NTSB No. CEN15MA290

Airbus Helicopters Service Bulletin No. AS350-67.00.64 (63 Pages)

SUBJECT: ROTOR FLIGHT CONTROLS - Double hydraulic servocontrols

"HYDR" test indication for double hydraulic servocontrols
 Corresponds to modification 074622

Figure 12

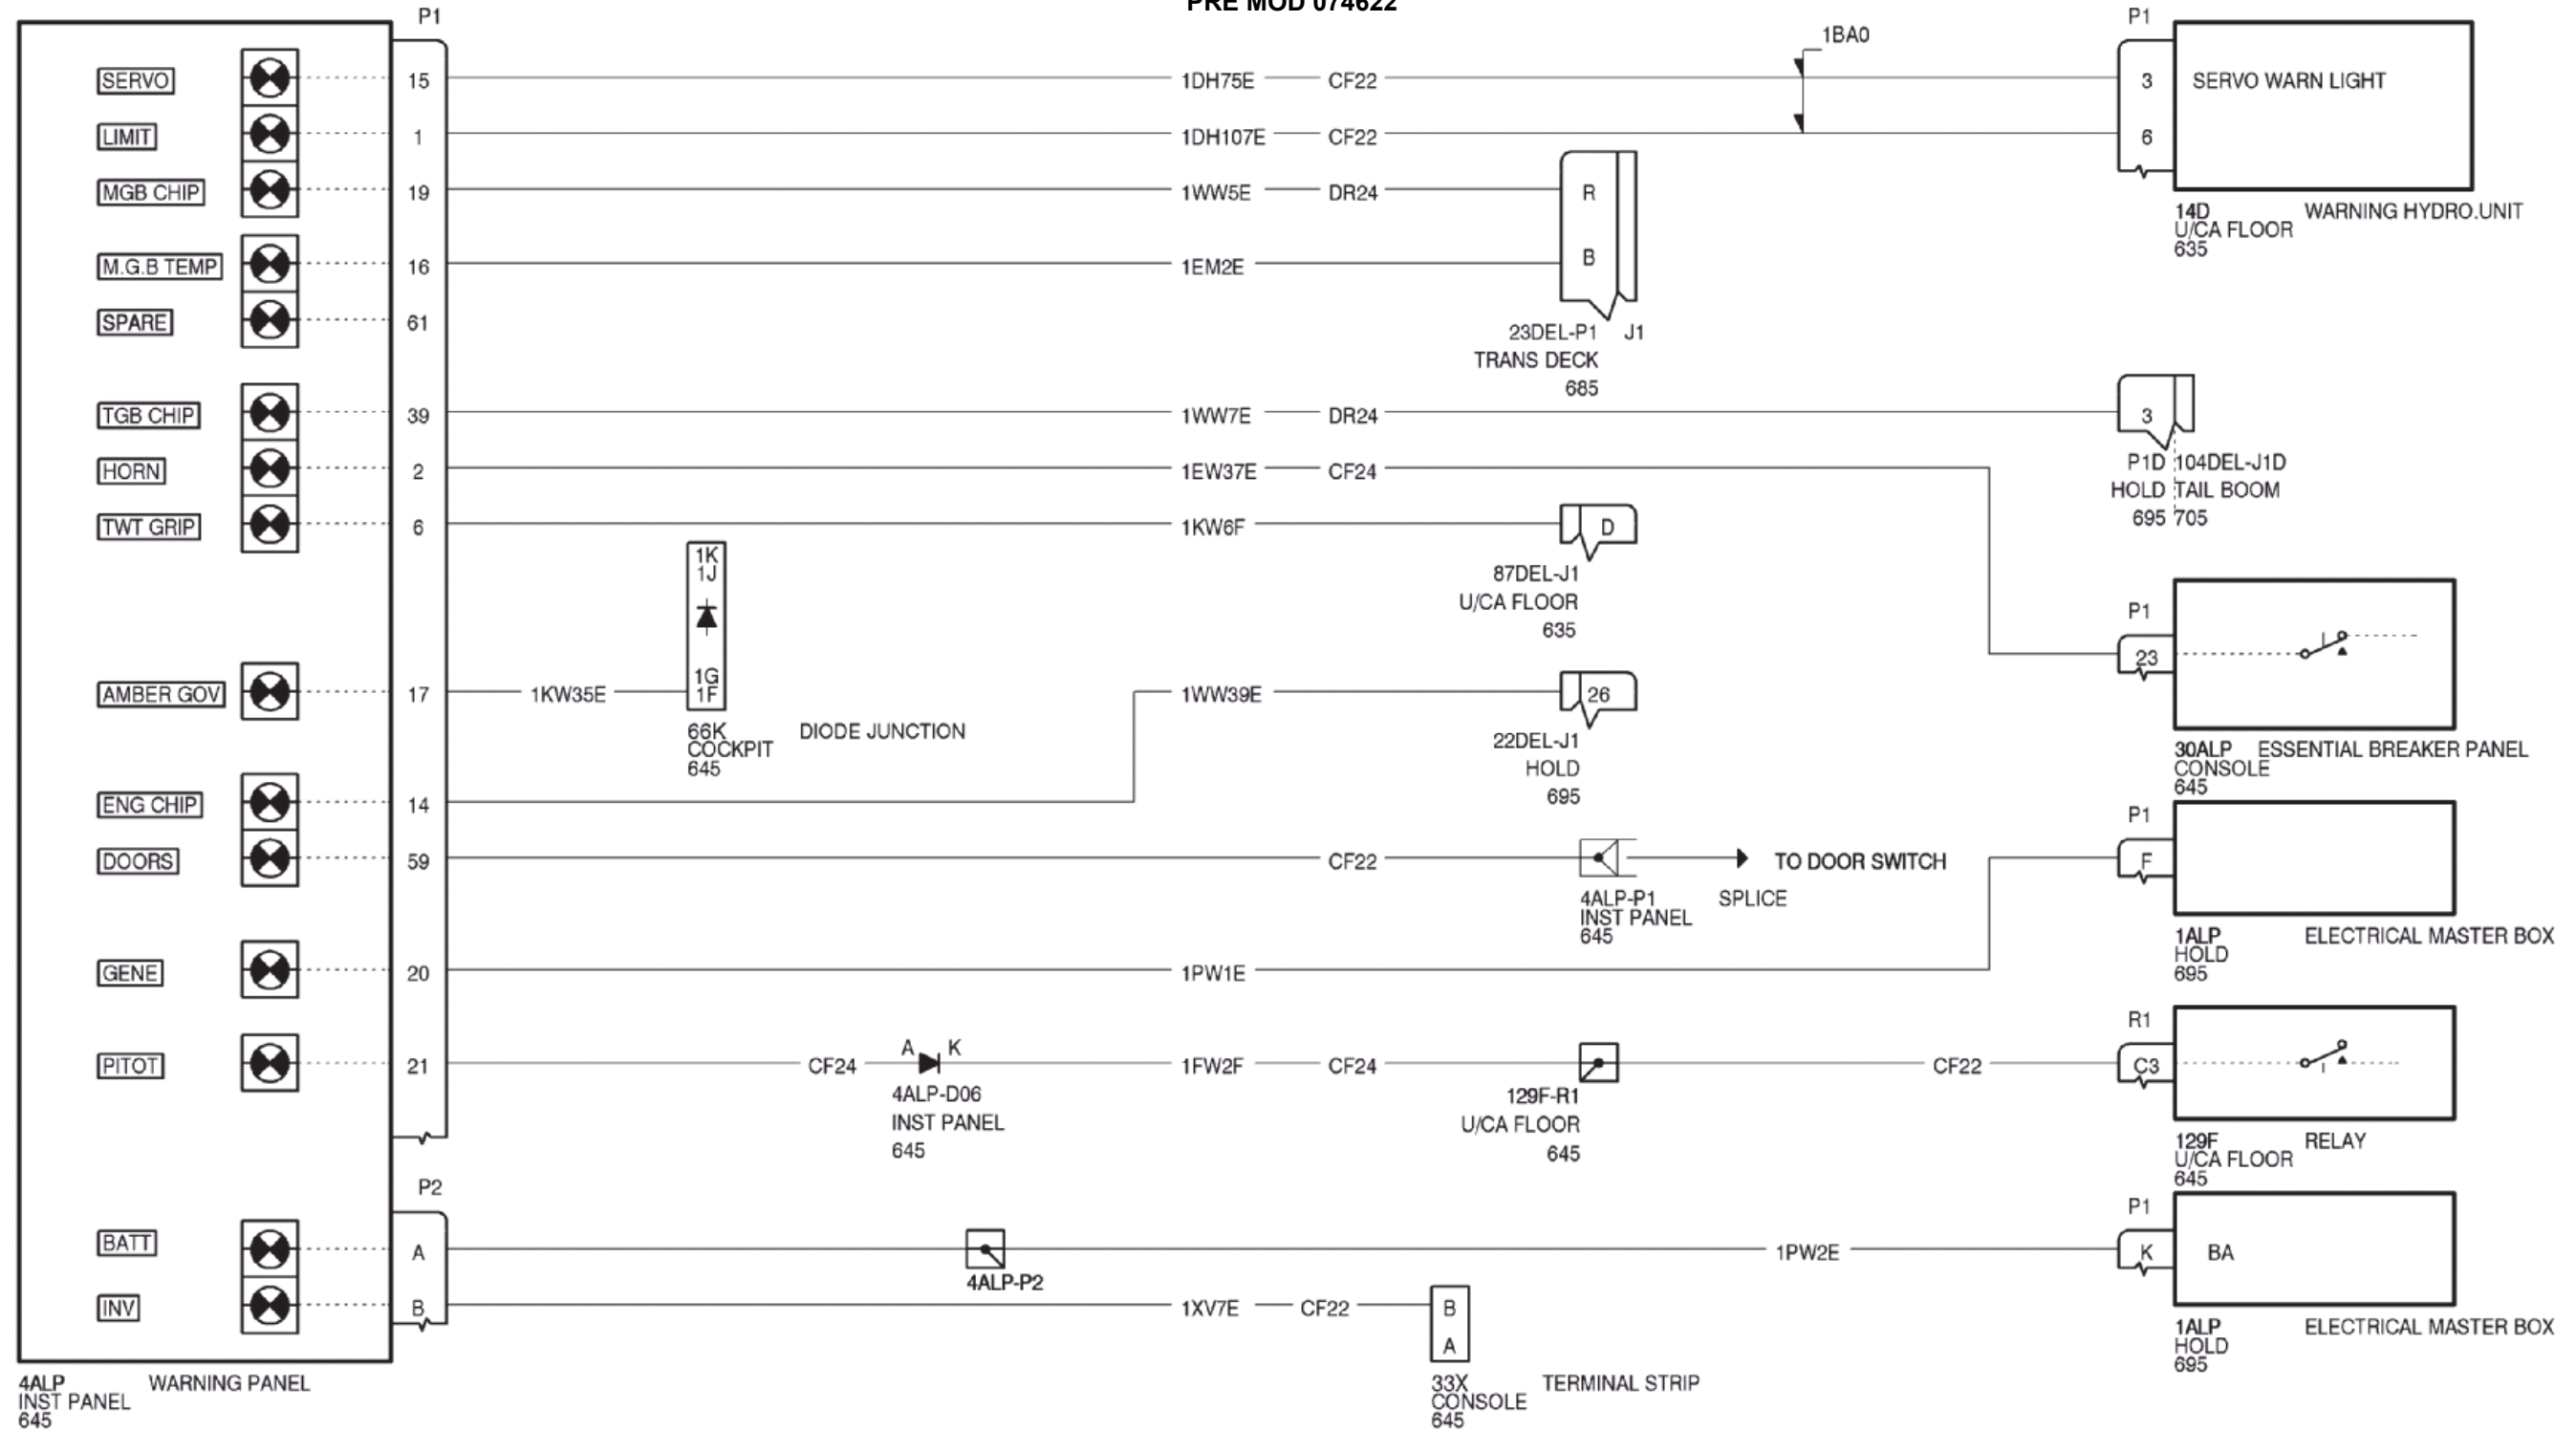
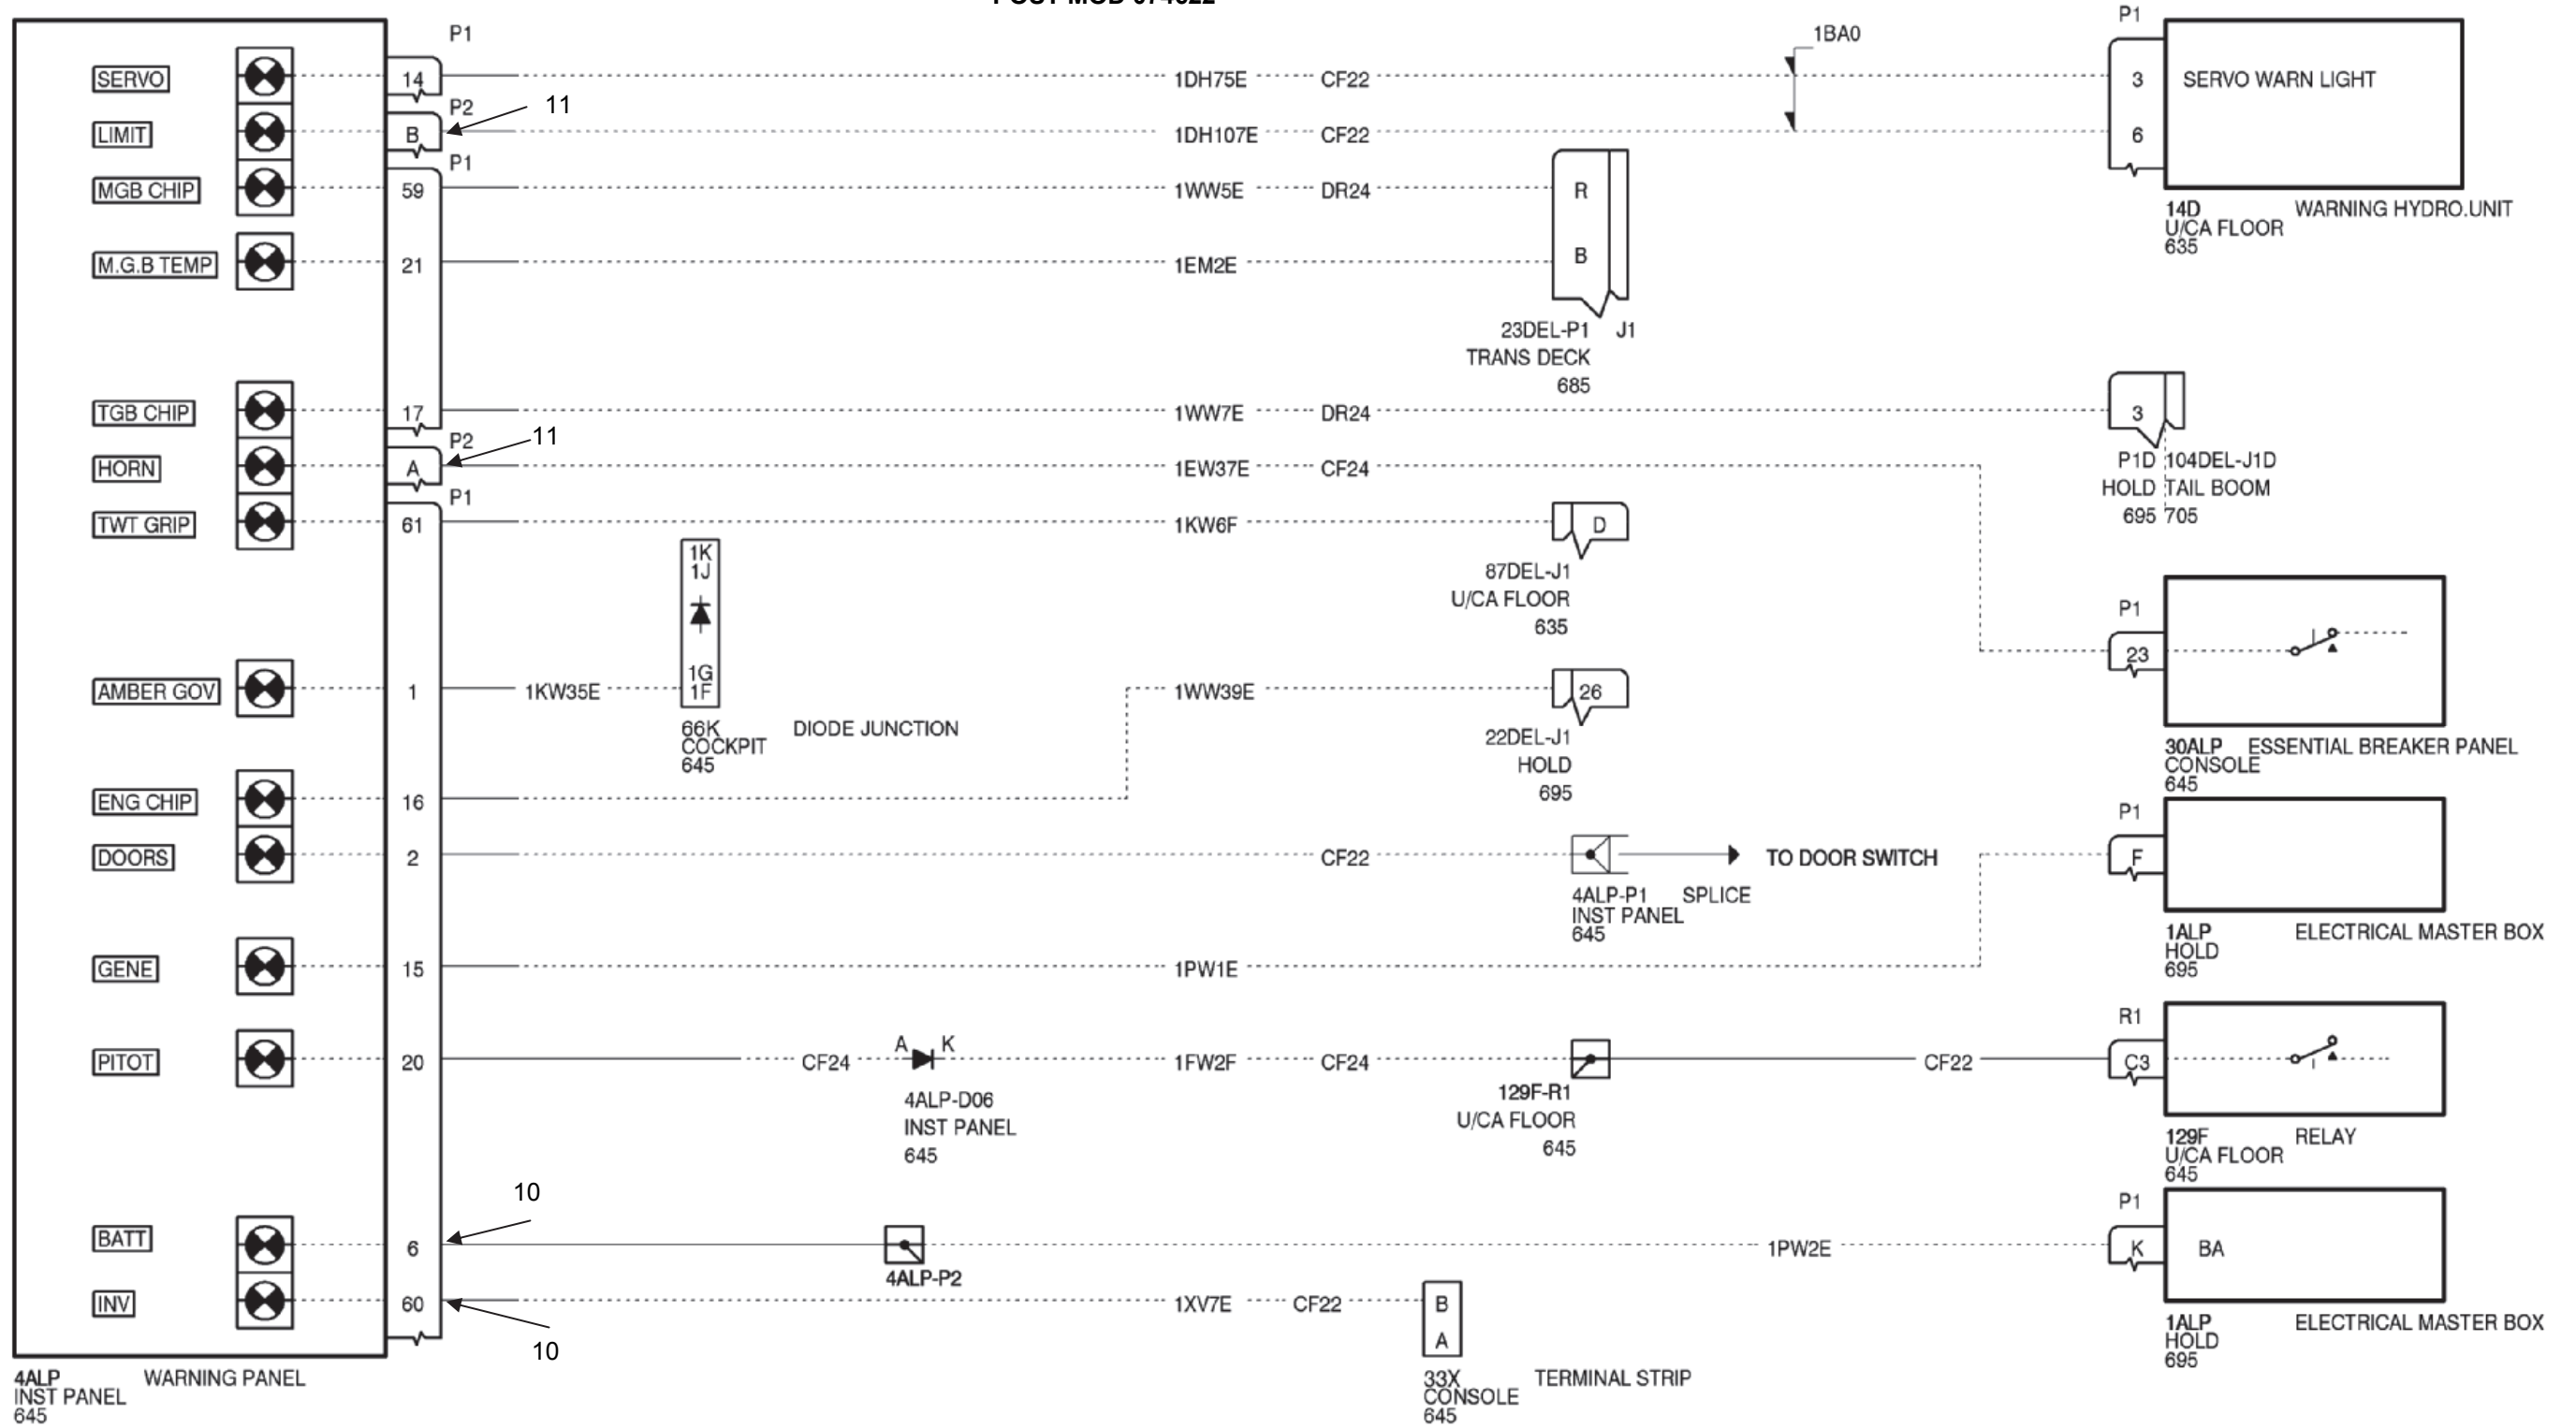
3.B.2.b.1. For helicopters POST MOD 073450 and PRE MOD 075601 (Figures 1, 2, 4, 5, 12 and 13)

- Cut and discard the binding clamps (not shown on Figures) that hold the electrical harnesses.
- Install base (3) on relay support (14) (Figure 1) with its bolts and nuts.
- Route the wiring using sets of wires and markers (1) and (33) and wire to contacts (4), (8), (10) and (11), ground contacts (12) (refer to appendix 4.A.), extensions (9) and (19), module (5) and its adapter (7), as per Figures 2, 4, 5, 12 and 13.
- Carry out a continuity test of the modified wiring.
- Install timer relay (2) on base (3).
- Attach the electrical harnesses with binding clamps (31) or (32) (not shown on Figures).

Figure 14

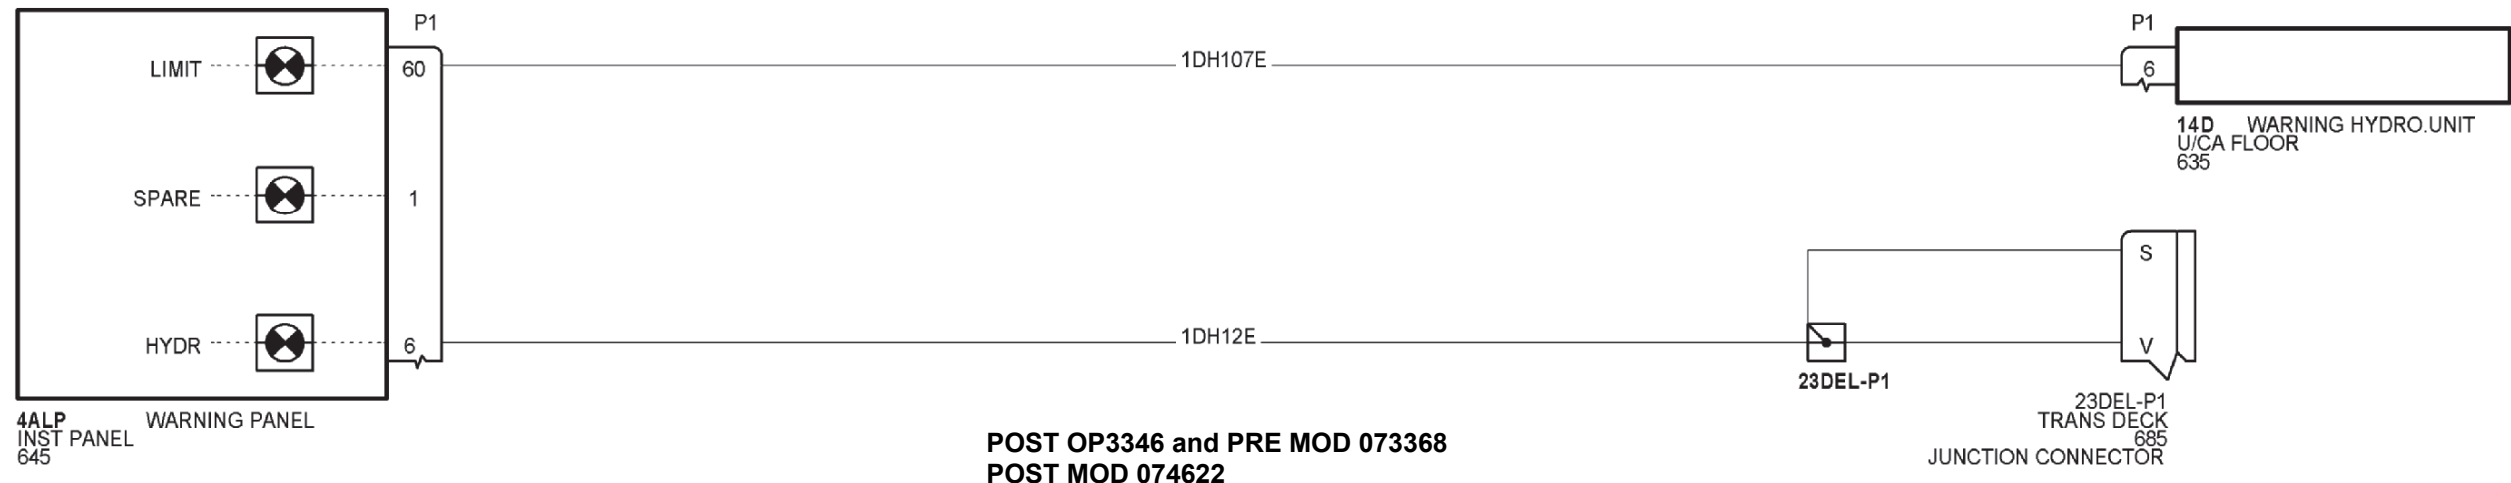
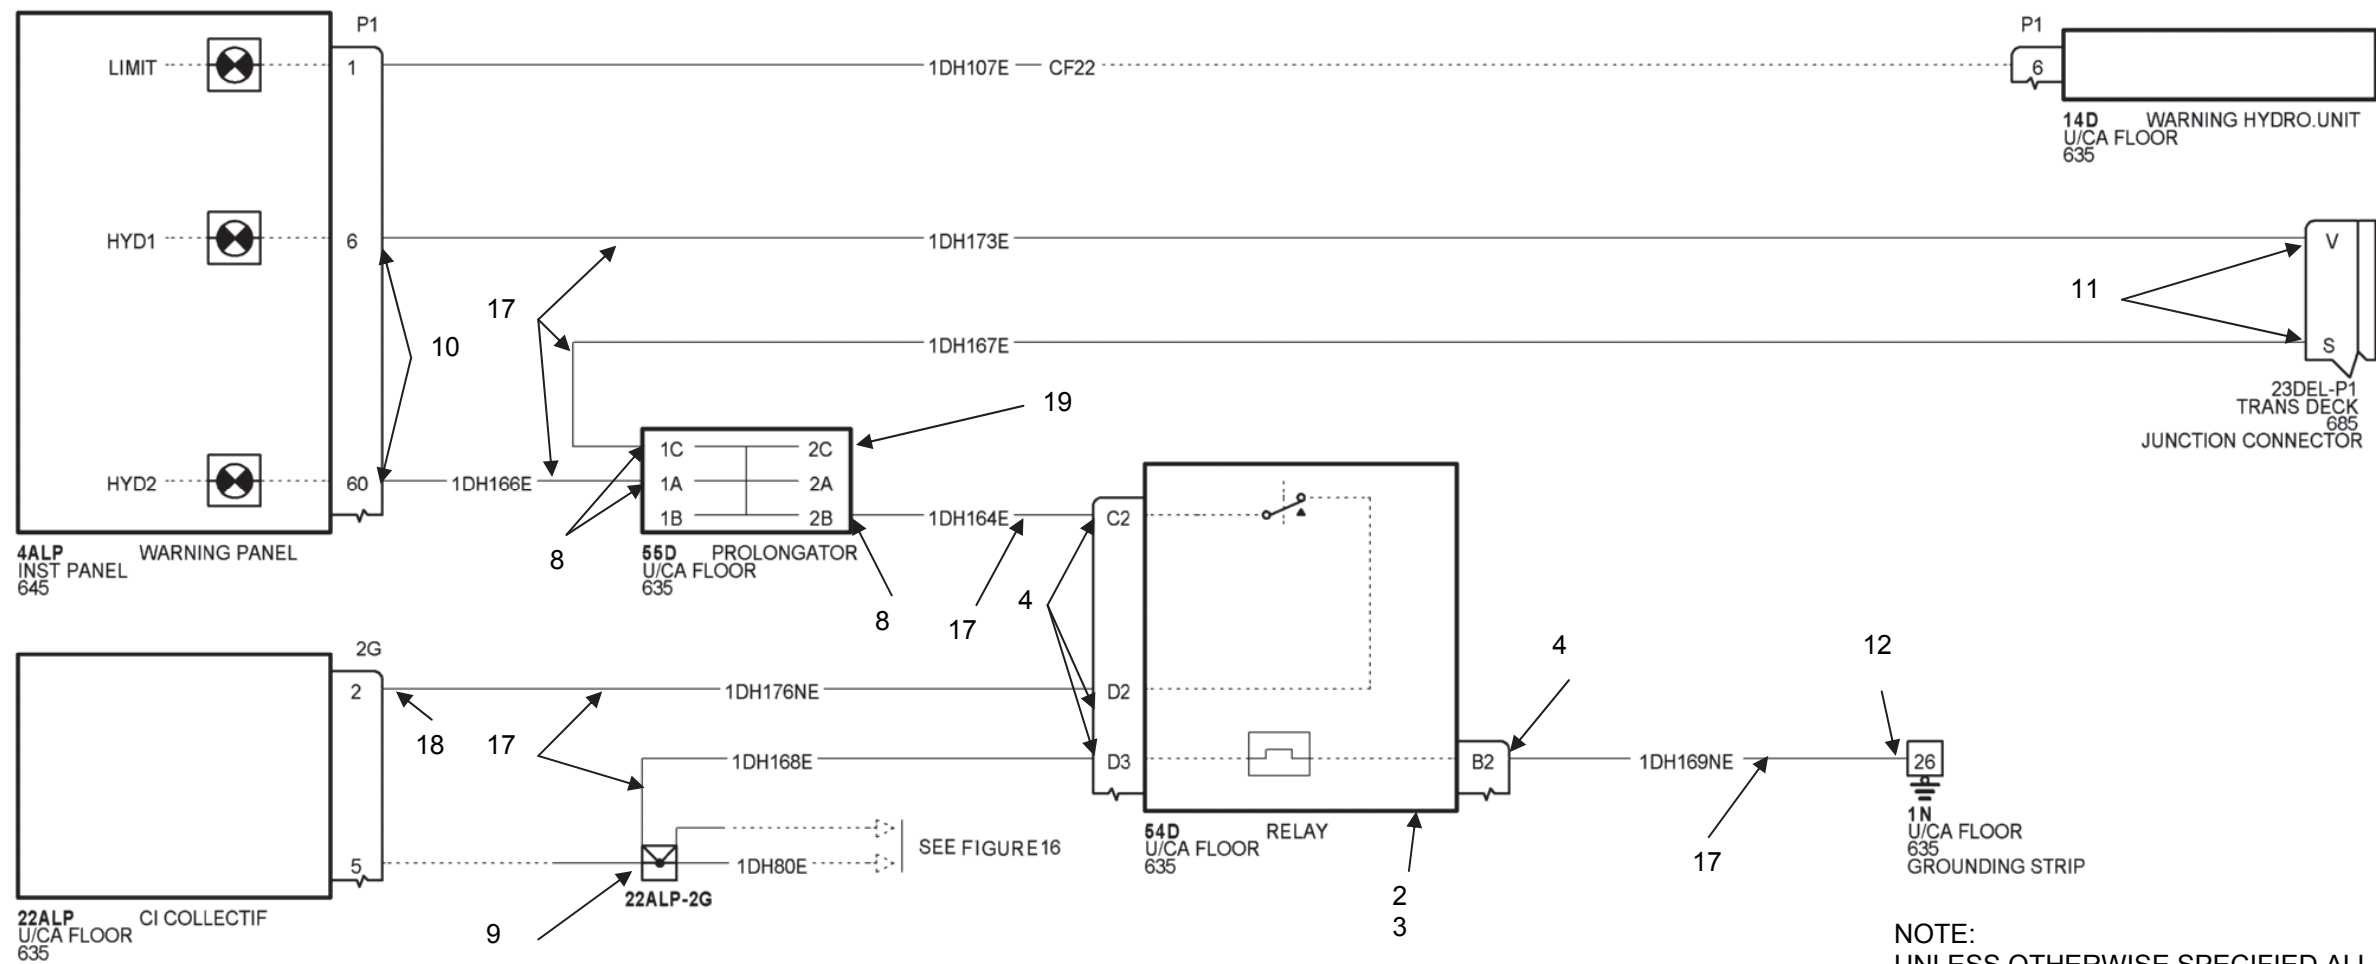
3.B.2.b.5. For helicopters POST OP 3346 and PRE MOD 073368 (Figures 1, 14, 15 and 16)

- Cut and discard the binding clamps (not shown on Figures) that hold the electrical harnesses.
- Install base (3) on relay support (14) (Figure 1) with its bolts and nuts.
- Route the wiring using sets of wires and markers (17) and wire to contacts (4), (8), (10) and (11), ground contacts (12) (refer to appendix 4.A.), PCB (CI) contacts (18) (refer to appendix 4.B.) and extensions (9) and (19) as per Figures 14, 15 and 16.
- Carry out a continuity test of the modified wiring.
- Install timer relay (2) on base (3).
- Attach the electrical harnesses with binding clamps (31) or (32) (not shown on Figures).
